**NSLPP MEETING HELD ON 02/10/2024****Attachments:**

ADDRESS: 85 Cremorne Road, Cremorne Point**APPLICATION NO:** DA 354/23

PROPOSAL: Alterations and additions to an attached dual occupancy including demolition of existing garage structure, and the construction of new garage structure with studio above, landscape works and installation of lift.

OWNER: Graham Costello & Diane Quittner**APPLICANT:** Test Before You Invest**AUTHOR:** Report of Robin Tse, Senior Assessment Office**DATE OF REPORT:** 20 September 2024**DATE LODGED:** 20 December 2023**AMENDED:** 6 April 2024**RECOMMENDATION:** Refusal

Figure 11: Maximum Building Height

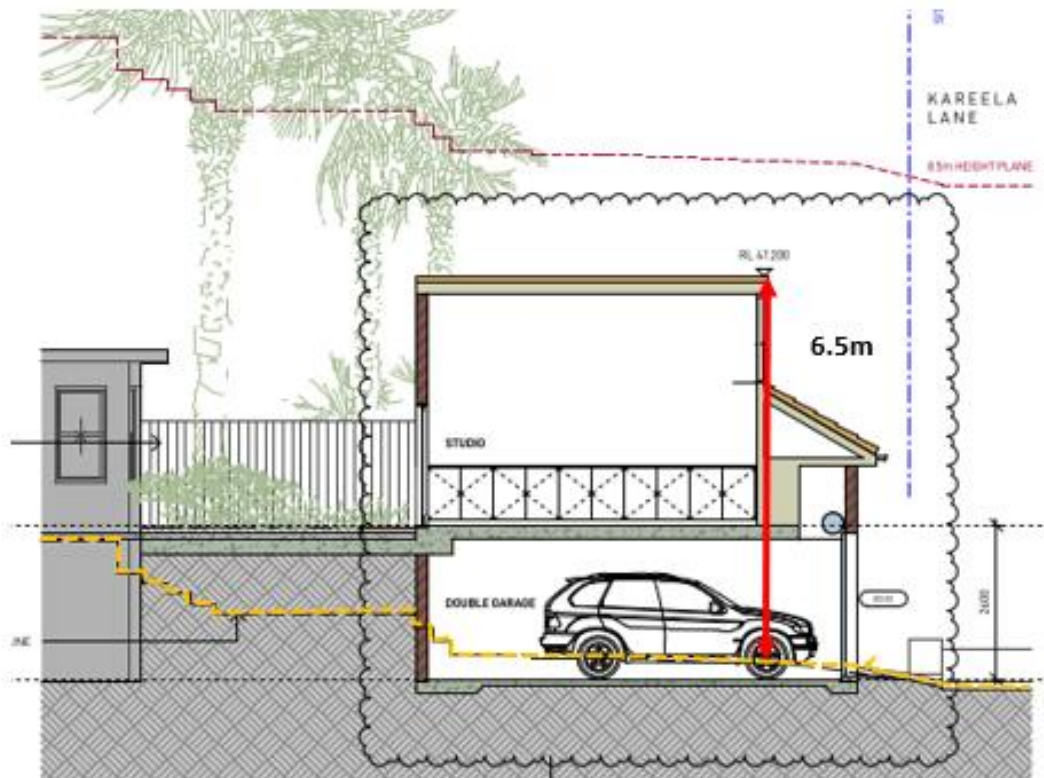
The proposed garage/studio building would have a maximum height of 6.5m that complies with the permissible height limit of 8.5m in accordance with clause 4.3 in NSLEP 2013.

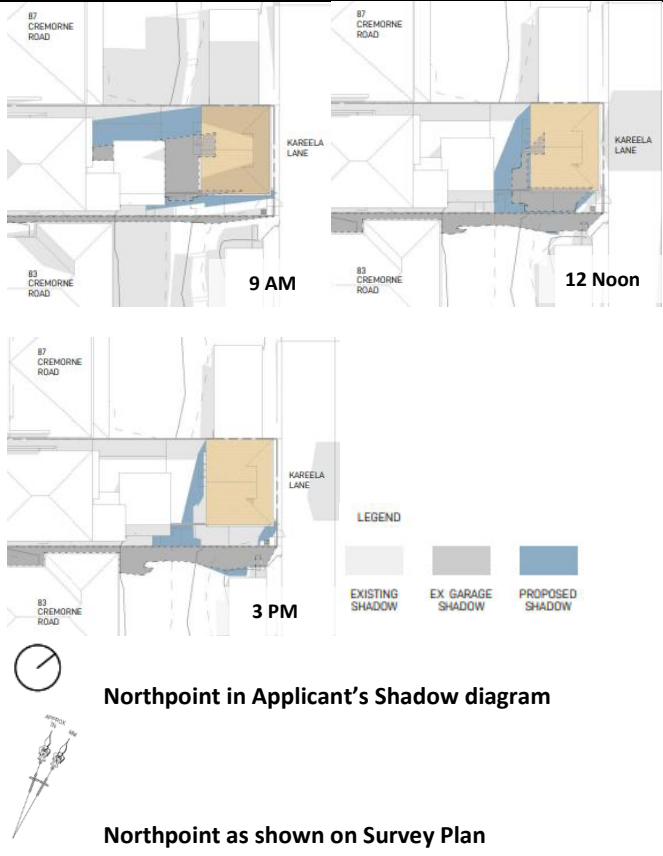
1.3.7 Solar Access	No	The proposed garage/studio building is likely to cause some additional shadowing of the rear communal area of the apartment development at No. 83 Cremorne Road. An assessment of the shadow diagrams submitted by the applicant has revealed that there would be additional shadowing on the communal area of No. 83 Cremorne Road during mid winter because the submitted diagrams appear to have been drawn based on an erroneous north point. The rear communal area of No. 83 Cremorne Road is unlikely to receive the required 3 hours of sunlight to the entire area between 9am and 3pm during mid winter due to height, bulk and scale of the proposed garage/studio building and the southerly aspect of No. 83 Cremorne Road.

<p>Northpoint in Applicant's Shadow diagram</p> <p>Northpoint as shown on Survey Plan</p> <p>Figure 12: Submitted Mid winter shadow diagrams</p>
<p>1.3.8 Acoustic Privacy 1.3.10 Visual Privacy</p>	<p>Acceptable on merit/via condition</p>	<p>The existing settings of the subject site and the adjoining properties, with rear gardens/terrace and existing windows on the rear elevations of apartment buildings, have resulted a degree of mutual overlooking and noise affecting these properties.</p> <p>The proposed garage/studio building is unlikely to cause significant privacy impacts because there would be no large openings facing the adjoining properties.</p> <p>The proposed elevated terrace between the main building and the studio would result in some overlooking of the neighbouring properties, these localised impacts can be dealt with by privacy screens or other appropriate privacy protection devices.</p> <p>There would be additional noise from the use of the elevated terrace and planting equipment. These impacts are considered to be acceptable given that the property would remain as a residential use and appropriate conditions can be imposed to manage noise from the use of plant equipment should approval be granted for the application.</p>
